Well Name: CO 10 15 FEDERAL	Well Location: T25S / R32E / SEC 10 / NENW / 32.150076 / -103.666425	County or Parish/State: LEA / NM
Well Number: 628H	Type of Well: OIL WELL	Allottee or Tribe Name:
Lease Number: NMLC061936	Unit or CA Name: COTTON DRAW UNIT	Unit or CA Number: NMNM70928X
US Well Number: 3002554203	Operator: CHEVRON USA INCORPORATED

Type of Submission: Notice of Intent

Type of Action: APD Change

Procedure Description: CHEVRON USA INC REQUESTS THE FOLLOWING CHANGES ON CO 10 15 FEDERAL 628H CHANGE THE POOL CODE AND POOL NAME OLD: POOL CODE- 96715 POOL NAME- WC-025 G-06 S253209L;BONE SPRING NEW: POOL CODE - 98270 POOL NAME- WC-025 G-08 S253216D; UPPER WOLFCAMP CHANGE LAST TAKE POINT OLD: SECT 34 100' FNL 650' FWL NEW: SECT 15 100' FSL 770' FWL CHANGE BOTTOM HOLE LOCATION OLD: SECT- 34 25' FNL 550' FWL NEW: SECT-15 25' FSL 770' FWL CHANGE THE PRODUCTION LINER OLD: 5.5' 20# NEW: 5' 13# REQUESTING TO HAVE A CONTINGENCY OF 5.5 17# SHOULD WE HAVE ANY ISSUES WITH USING THE 5.13# CHANGE TO THE SURFACE CASING SET DEPT PLEASE SEE ATTACHED NEW: C102, 9 PT DRILL PLAN, CASING DESIGN AND DIRECTIONAL DRILL PLAN

PROPOSED LAST TAKE POINT
 X=746,998.97
 Y=409,300.03
 LAT.32.123502°N
 LONG.103.668998°W

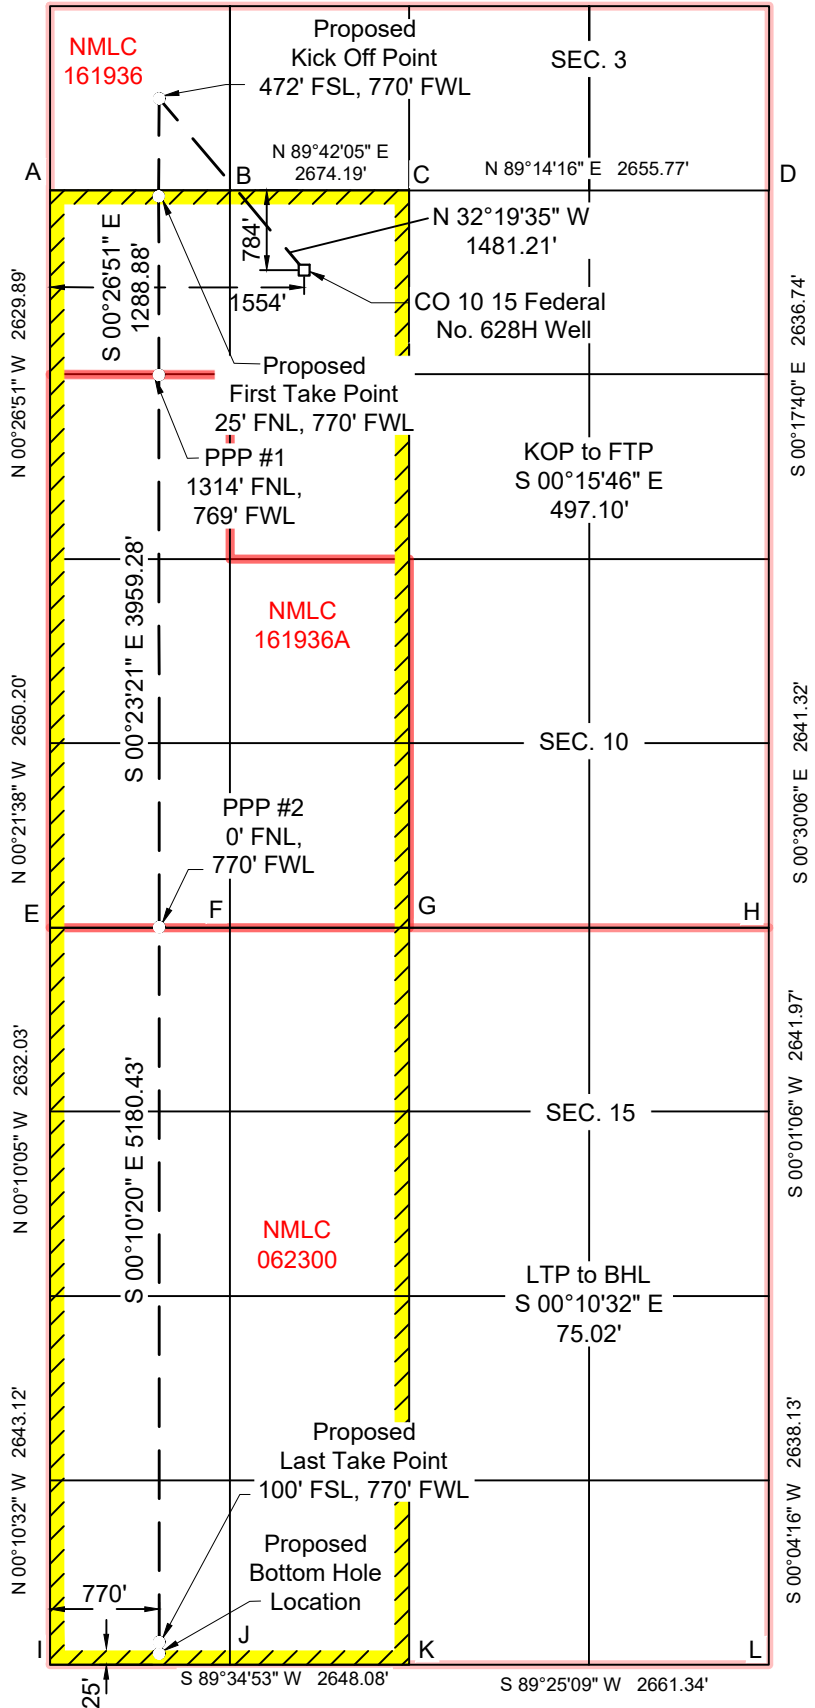
CHANGE LAST TAKE POINT

OLD: SECT 34 100' FNL 650' FWL

NEW: SECT 15 100' FSL 770' FWL

CHANGE BOTTOM HOLE LOCATION

OLD: SECT- 34 25' FNL 550' FWL

NEW: SECT-15 25' FSL 770' FWL
